US Army Corps
of Engineers®
Portland District

Final Environmental Assessment

SEDIMENT RETENTION STRUCTURE (SRS) SPILLWAY RAISE PROJECT

MOUNT ST. HELENS SEDIMENT MANAGEMENT FOR FLOOD RISK REDUCTION

Figure 12. Affected Creeks in Predicted Area of Inundation for Proposed 10-foot Spillway Raise

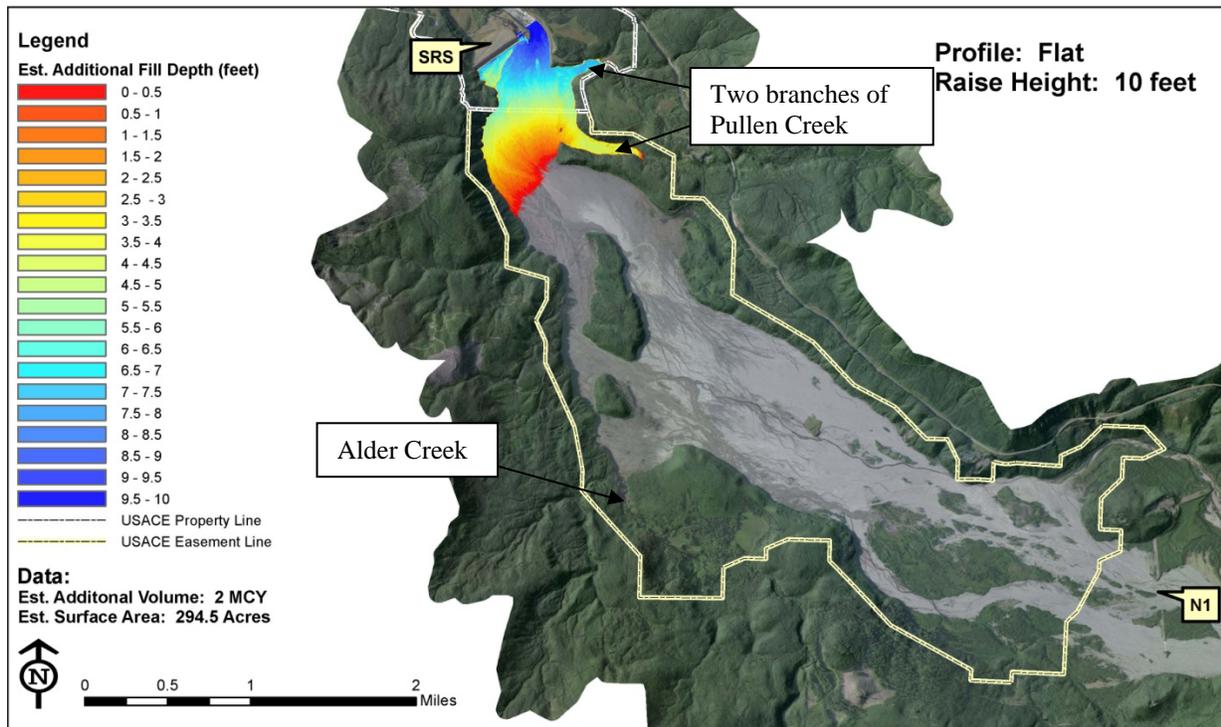
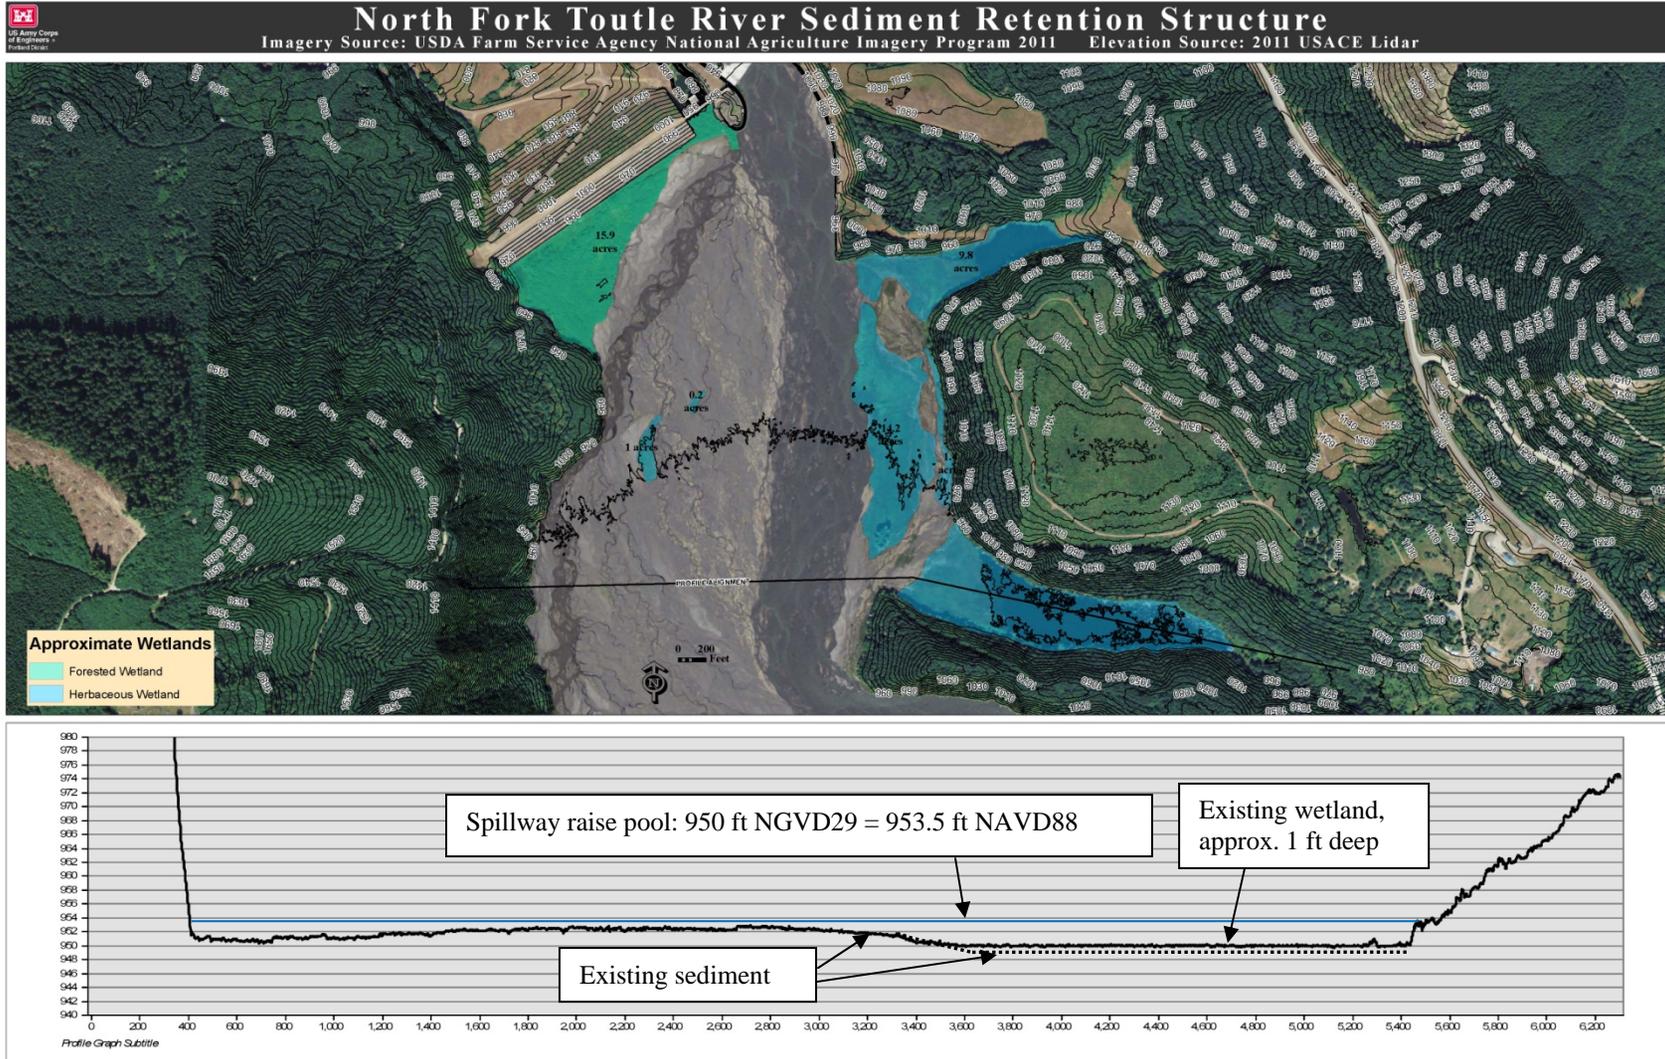
h. Figure 7 shows only a limited area flooded from 0-10 feet. A thorough land survey must be completed to identify the lateral and upper extents of expected sediment deposition such that an honest evaluation of impacted areas can be made. Impacted areas will include jurisdictional wetlands, streams and forested upland habitats. Impacts to these critical areas must be quantified and mitigated under local, state and federal regulations.

Corps Response: Sections 3 (Affected Environment) and 4 (Environmental Consequences), including Figures 12, 13, and 14 have been updated in the revised draft EA.

Figure 16. LiDAR Vegetation Analysis for FEDS and 10-foot SRS spillway Raise in 2035

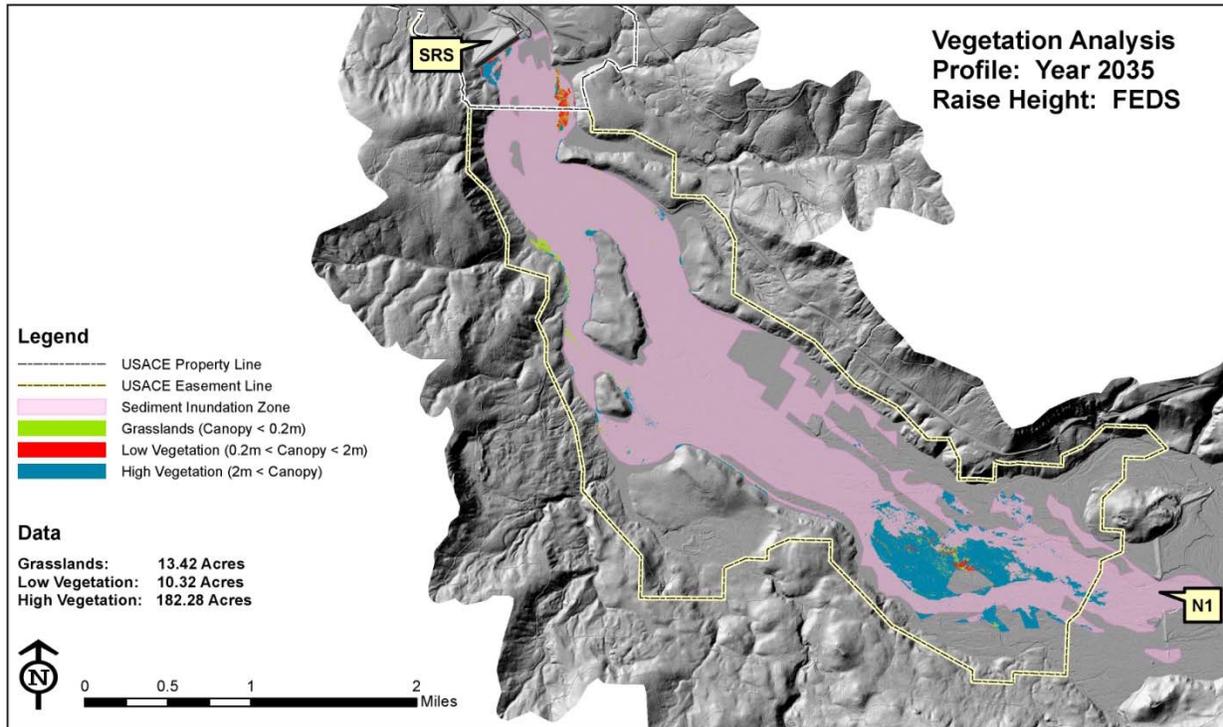
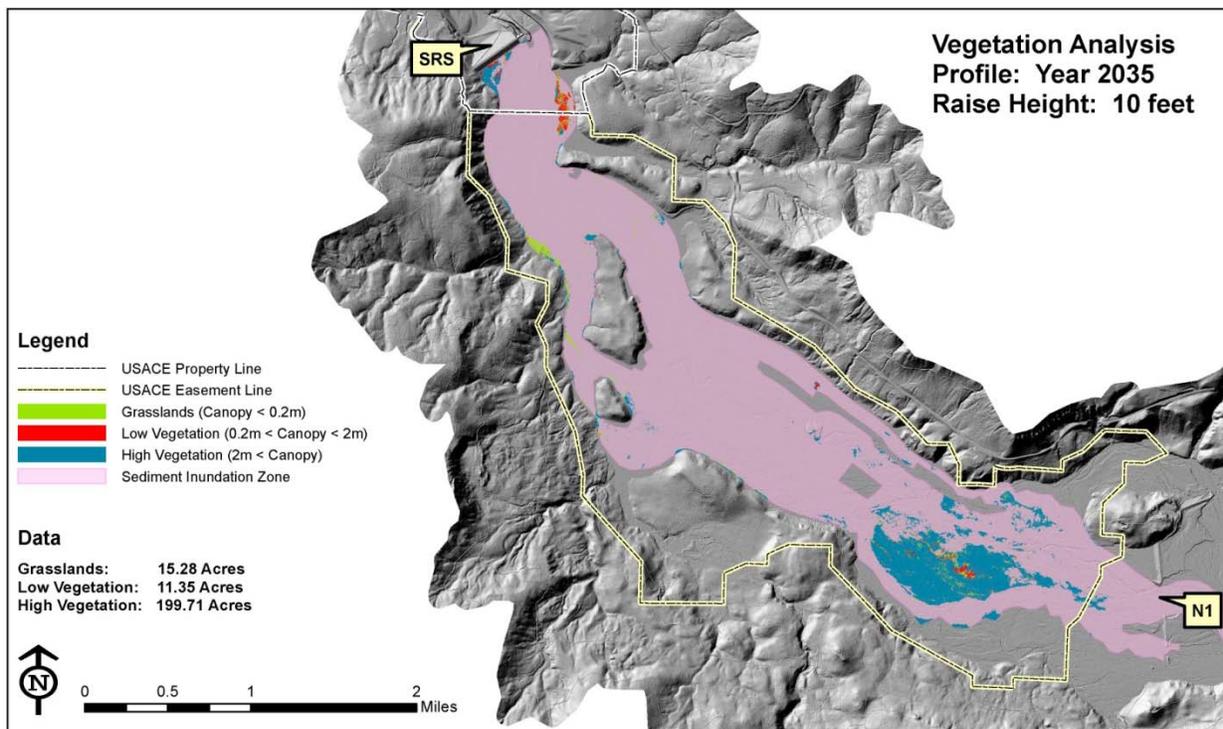
c. It is clear to us that there is a change in circumstances not contemplated in the 1984 EIS and associated mitigation plan, and therefore a new EIS should be considered. Our position is partially supported by the fact that Figure 16 of the revised Draft EA shows the proposed spillway raise would cause additional sediment inundation outside the USACE easement, onto properties owned by WDFW.

Corps Response: See response to comment 1(f) above. Sediment deposition in figure 16 does show modeled deposition outside the easement area in the year 2035 both with and without the project. The differences are minor and likely within the range of variability for a predictive model and do not in itself warrant an evaluation at the EIS scale. The Corps continues to monitor sediment deposition and may need to address in the long term sediment management and flood risk reduction efforts.
